Access Compliance Report

Public Rights-of-Way

(Curb Ramps)

Intersection ID: 26633	Main Street: WEDDINGTON_RD	Cross Street: FINCHER_MEADOWS_LN	Location: NE
ADA ID: 4EBB7C3D35C7	Ramp Type: Perp	Initial Pass/Fail: Fail	Overall Compliance: No
			Severity Score: 13.75

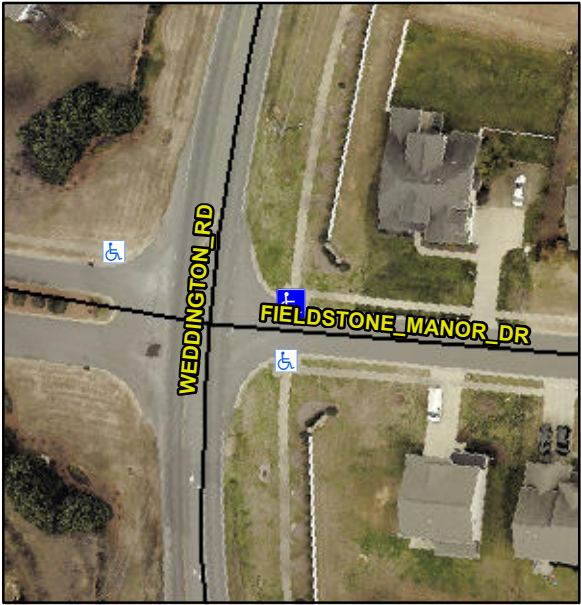
Codes/Mitigation Info/Possible Solution			Field Measurements/Component Compliance		
	Possible Solutions:		Compliance	Description	Data
	Remove & Replace Entire Ramp.		No	Ramp Length (in)	96.0
			Yes	Ramp Width (in)	48.0
			N/A	Flare Type LT	N/A
			N/A	Flare Slope LT (%)	N/A
			N/A	Flare Traversable LT?	N/A
			N/A	Landing Length (in)	N/A
			N/A	Landing Width (in)	N/A
			N/A	Landing Slope (%)	N/A
			N/A	Landing X Slope (%)	N/A
<p>Surveyor Notes:</p> <p>N/A</p> <p>PROW/ADA:</p> <p>Not Found, R304.2.2, R304.5.3</p>			N/A	Flare Type RT	N/A
			N/A	Flare Slope RT (%)	N/A
			N/A	Flare Traversable RT?	N/A
			N/A	DWS Provided?	N/A
			N/A	DWS Contrast?	N/A
			N/A	DWS Length (in)	N/A
			N/A	DWS Full Width?	N/A
			N/A	DWS Offset (in)	N/A
			N/A	Gutter Ponding?	N/A
			N/A	Gutter Lip Ht (in)	N/A
<p>Total Cost:</p> <p>\$ 1850.00</p>			No	Painted X Walk1?	N/A
			To S	X Walk 2 Direction	N/A
			N/A	X Walk 2 Width (in)	N/A

0.1	X Walk 2 Slope (%)	N/A
			5.3	X Walk 2 X Slope (%)	N/A
			N/A	Ramp inside XWalk1?	N/A
			N/A	Ramp inside XWalk2?	N/A
			N/A	Clear Space?	N/A
			N/A	Clear Space to XWalk (in)	N/A
			N/A	Storm Grate/Utility Hazard?	N/A
<p>Obstruction Type</p> <p>N/A</p>			N/A	Storm Grate/Utility Type	N/A
			N/A	Surface Condition? (G/P)	Good
